TECHNICAL SERVICE BULLETIN

23-2323

Vehicles Built To 20-Oct-2022 – Interior Rattle At The Front Of The Vehicle Below The Instrument Panel

Ford 2021-2023 Everest	Build Date: Up to 20 October 2022
2021-2023 Ranger	Build Date: Up to 20 October 2022

Figure 1

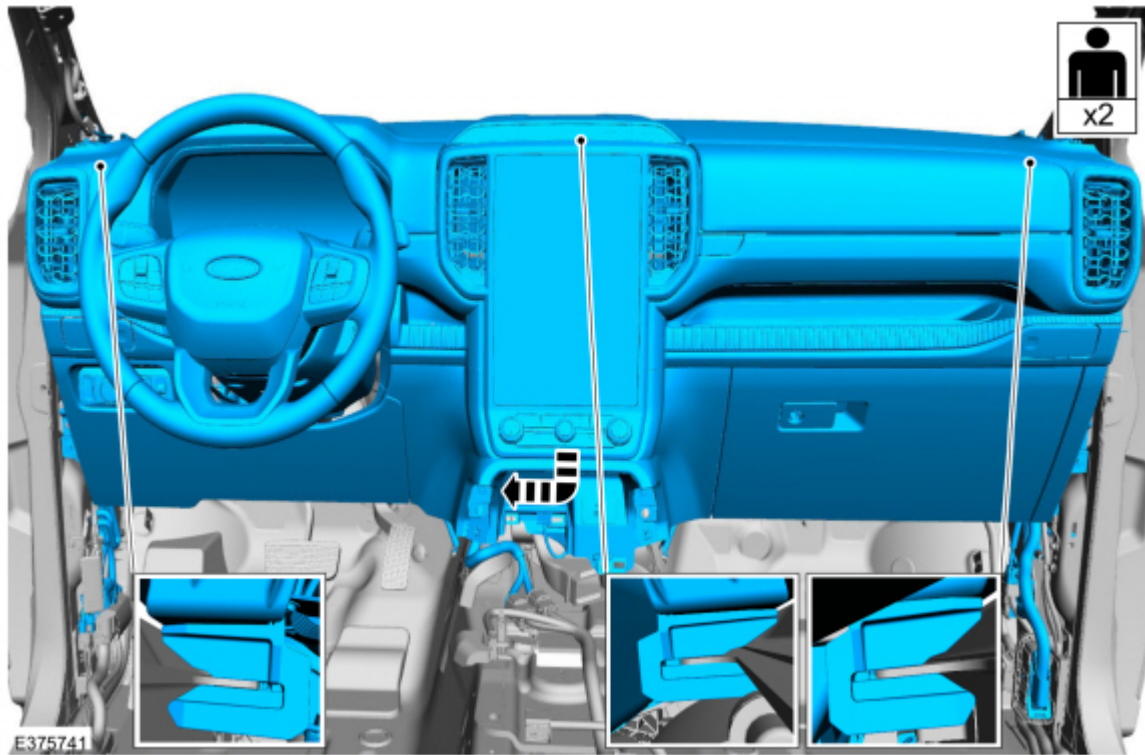
2. Check the color of the instrument panel clips installed on the instrument panel. (Figure 1 and 2).

(1). The clips will be either black in color or blue. Depending on the color, this will affect whether new clips are required in Step 5 or whether the existing clips can be re-used.

Figure 3

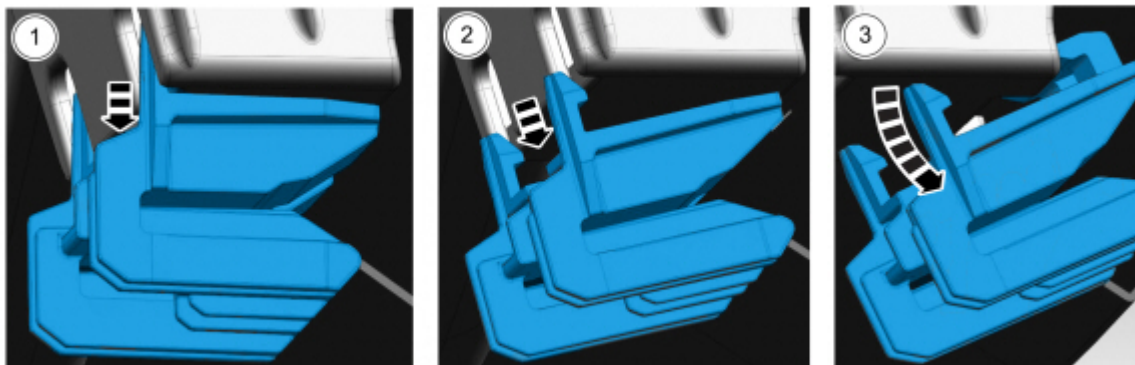
3. Remove the clips from the instrument panel (2 snaps) at the 3 locations. (Figure 3)

Figure 4

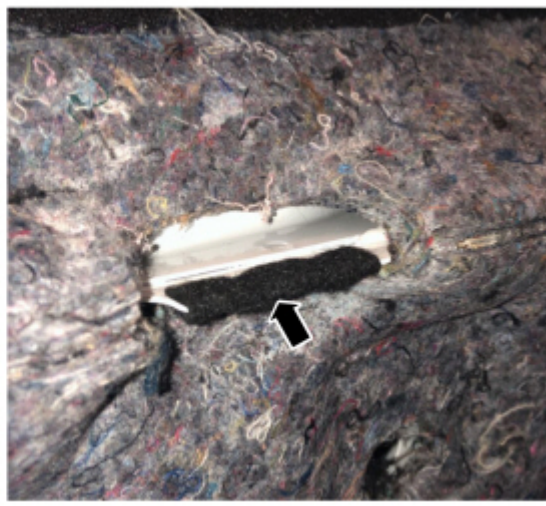
4. Add adhesive backed insulation (felt tape 1-2mm thick) around the edge of the instrument panel at the 3 clip interface locations. (Figure 4)

Figure 5

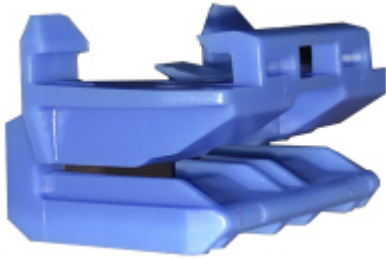
5. Install blue clips (Figure 5) at the 3 locations.

- (1). For vehicles identified with blue clips in Step 2 - re-install the blue clips at the 3 locations.
- (2). For vehicles identified with black clips in Step 2 - fit new blue clips (see Parts information) at the 3 locations.
